RE: **Comments of the Minnesota Department of Commerce, Division of Energy Resources**
Docket No. E017/M-21-225

Otter Tail Power Company's Annual Safety, Reliability and Service Quality Report and Proposed SAIFI, SAIDI and CAIDI Reliability Standards for 2021.

Comments of the Minnesota Department of Commerce Division of Energy Resources

Docket No. E017/M-21-225

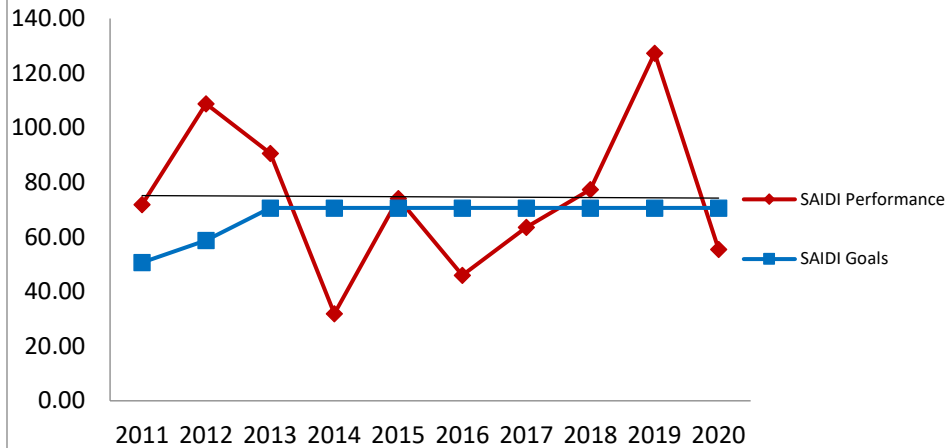
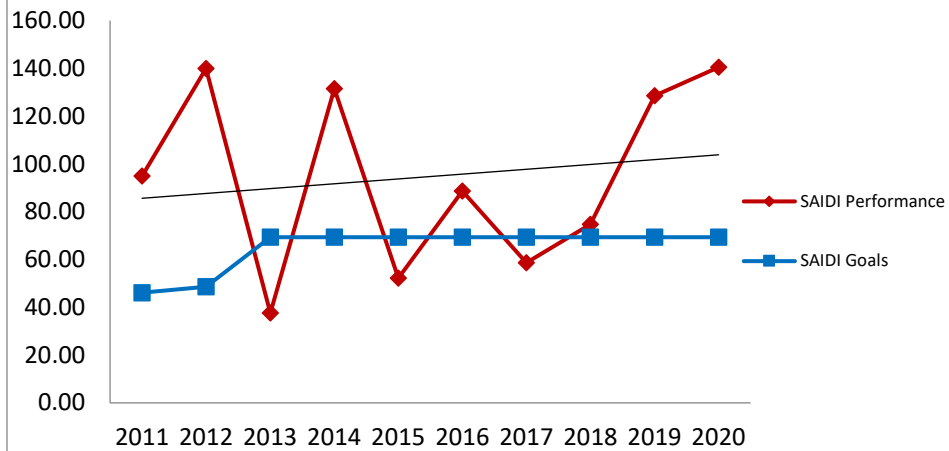
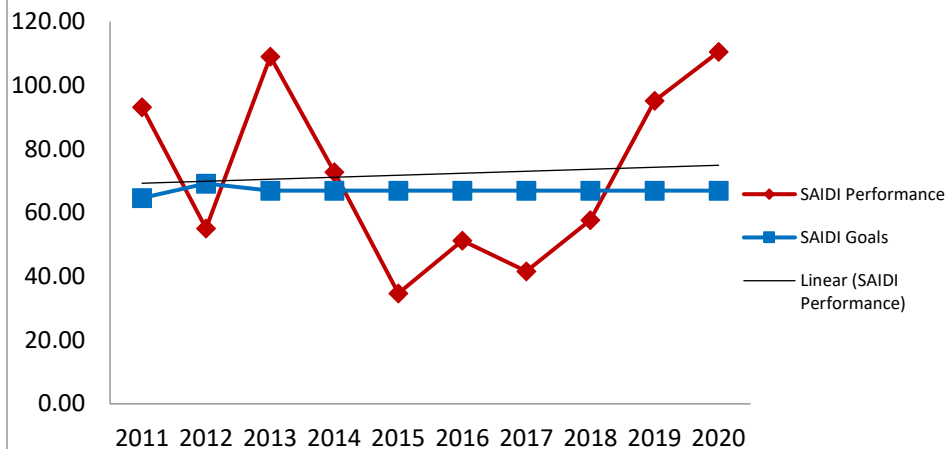
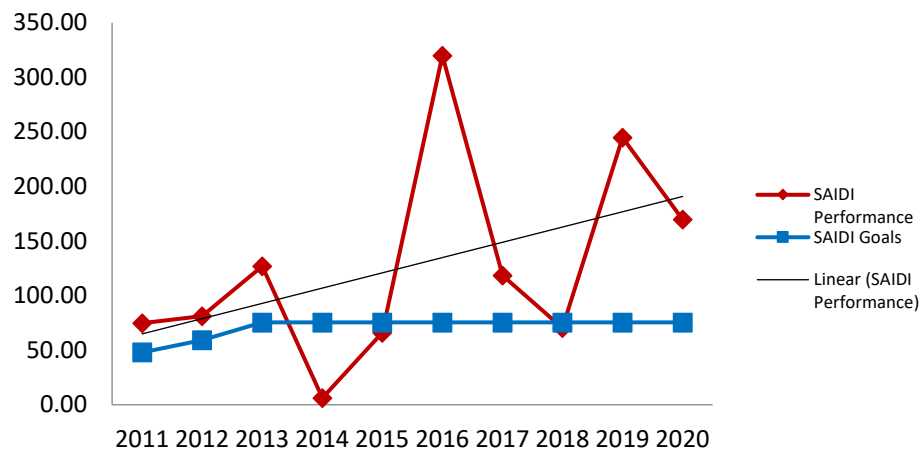
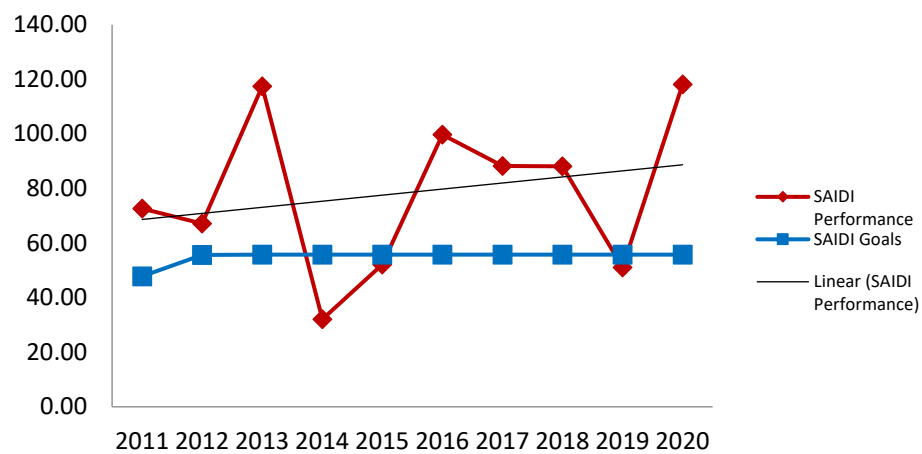
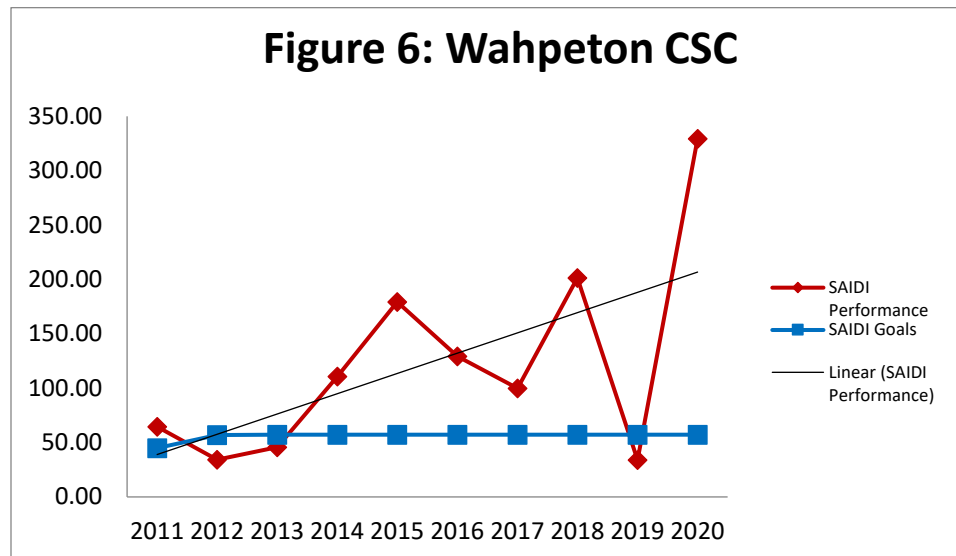
The following figures highlight OTP's SAIDI performance trends for the six CSCs from 2011-2020, including a black trend line to indicate performance patterns overtime. It should be noted that all CSCs other than Bemidji and Fergus Falls show trends of worsening performance.

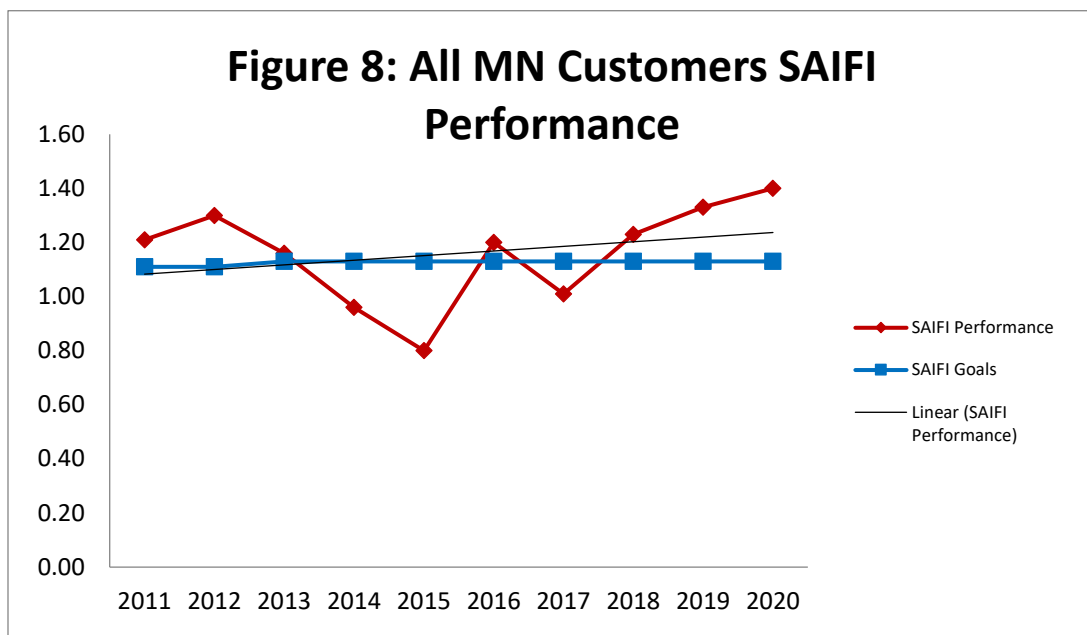
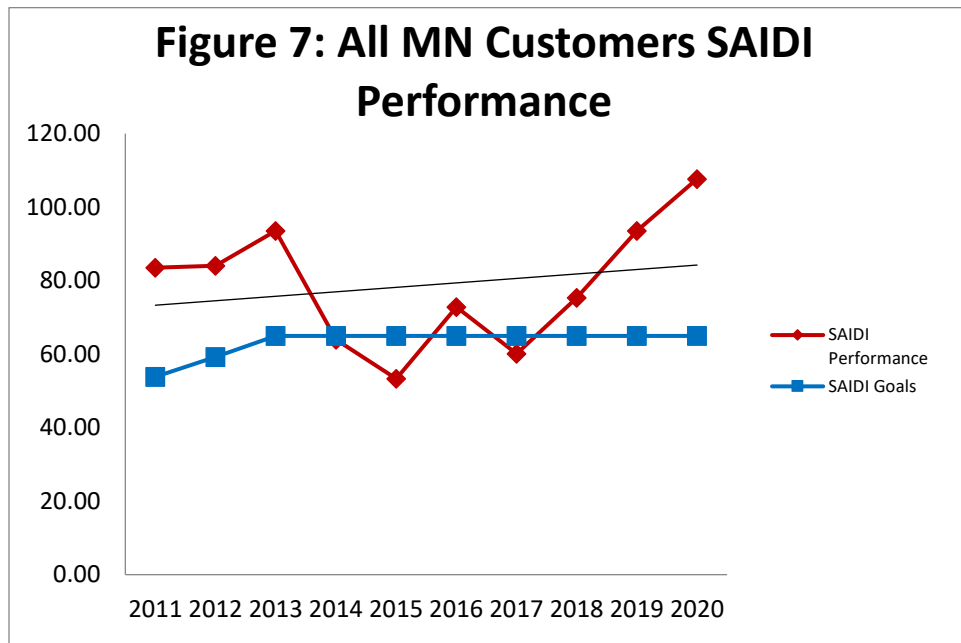
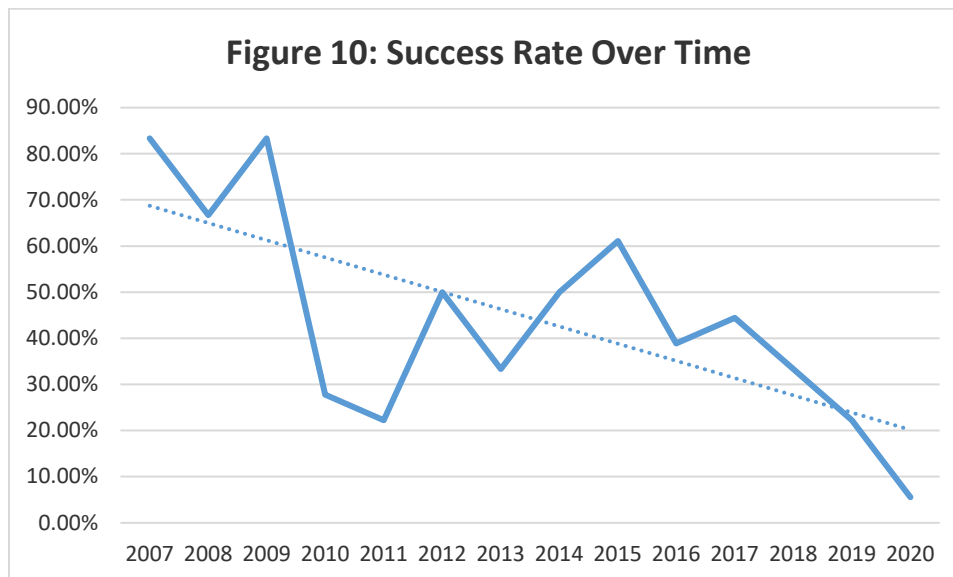
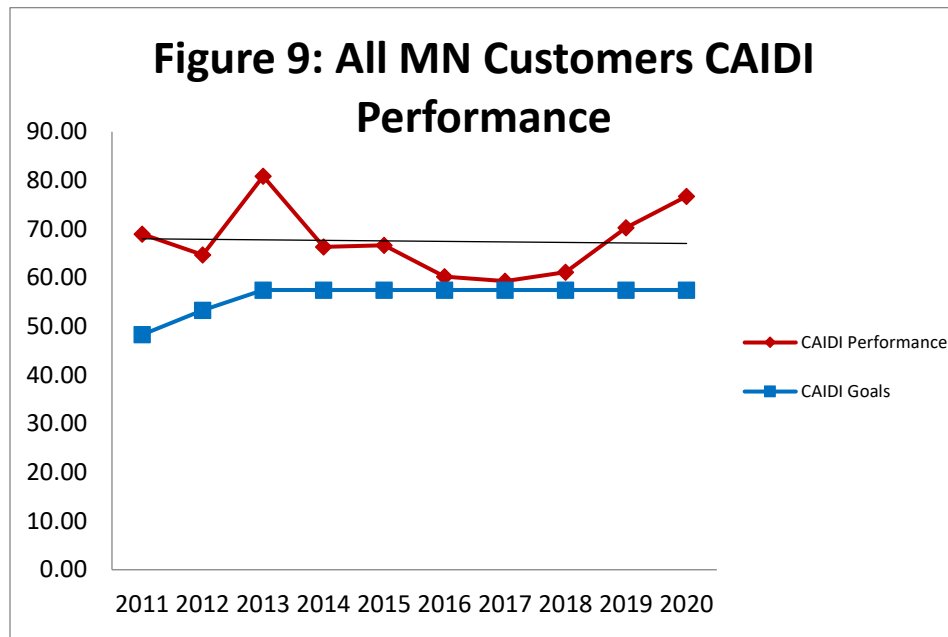
As can be seen from Figure 10 above, OTP has trended downward over time regarding its ability to meet its goals. On average, since 2006, OTP has achieved approximately 47 percent of its goals, with 2020 coming in lower than that at approximately 5.56 percent.
